Attachment D
**Modifications to the Project and
Additional Environmental
Documentation**

August 27, 2020

Subject: Veterans Industrial Park 215 - Modifications to the Project and Additional Environmental Documentation

Figure 4-3 Planning Area 1 Conceptual Landscape Plan

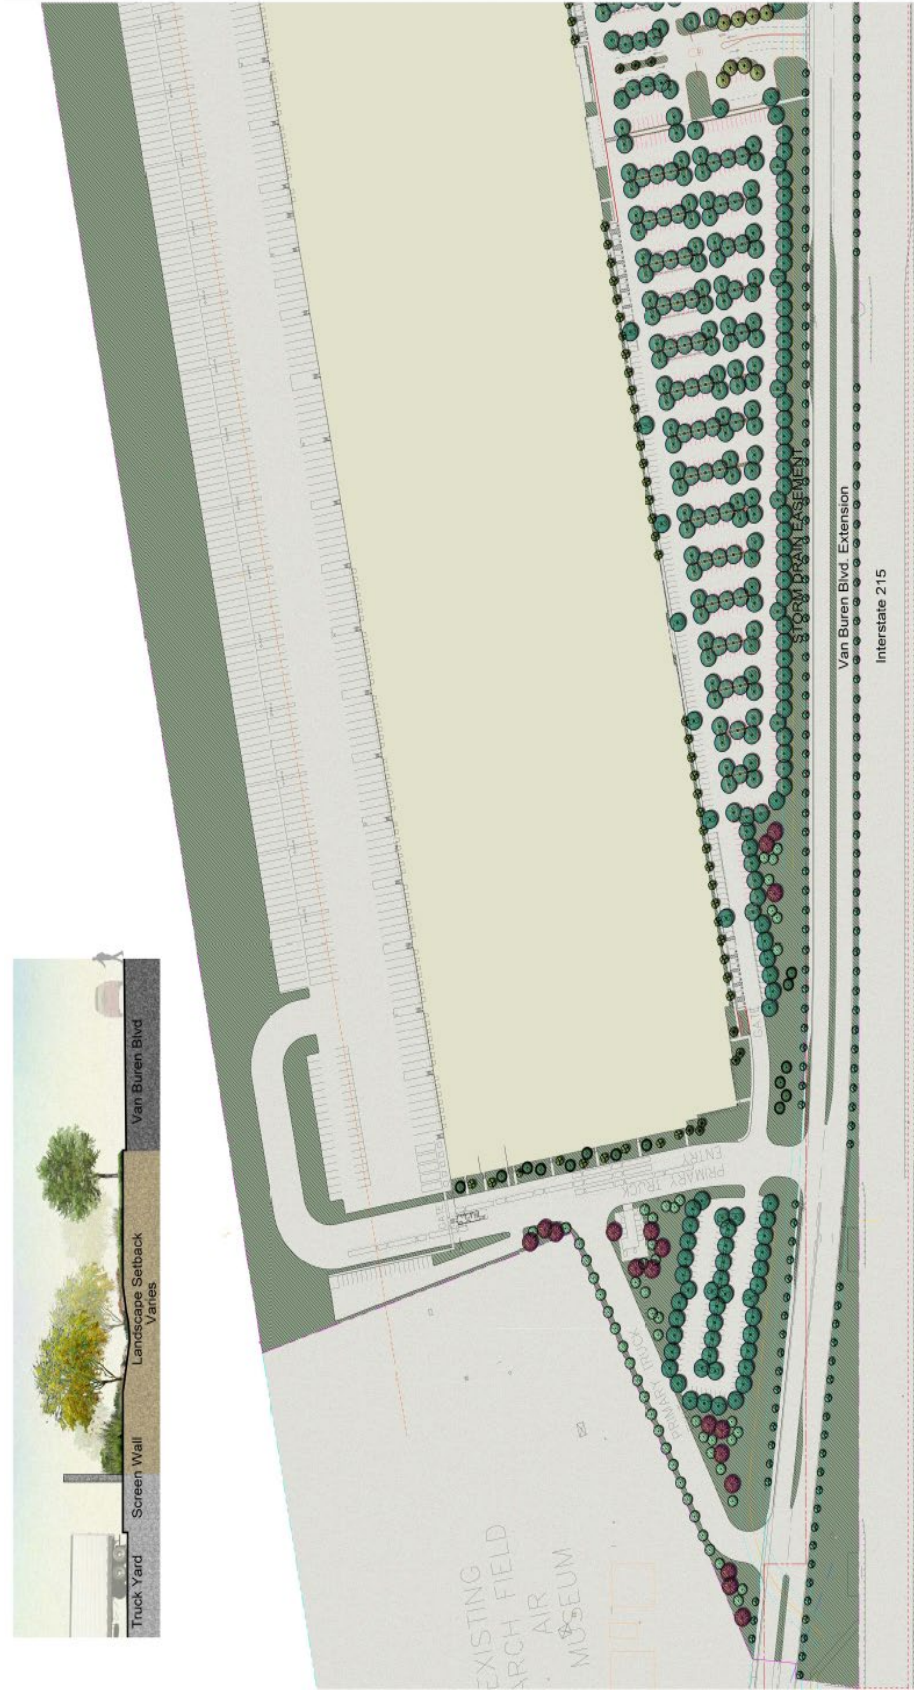
Section 4.3.1 of the Specific Plan has been revised to eliminate trees on the eastern side of the site proximate to the airfield and permit trees, shrubs, and ground cover plants west of the eastern façade of the proposed building(s). The conceptual landscape plans provided as Figures 4-3 and 4-4 have been revised to incorporate these changes. The plant materials palette has been modified and includes as revised Table 4-1 in the Specific Plan.

As stated above, the landscaping for the project has been modified based on input provided by the Riverside County ALUC during its consideration of the Single Building Option’s consistency with the adopted March Air Base/Inland Port ALUCP. The landscaping was modified to eliminate trees that would bear mast or grow to an adequate size for roosting so that potential conflicts between birds and aircraft are eliminated.
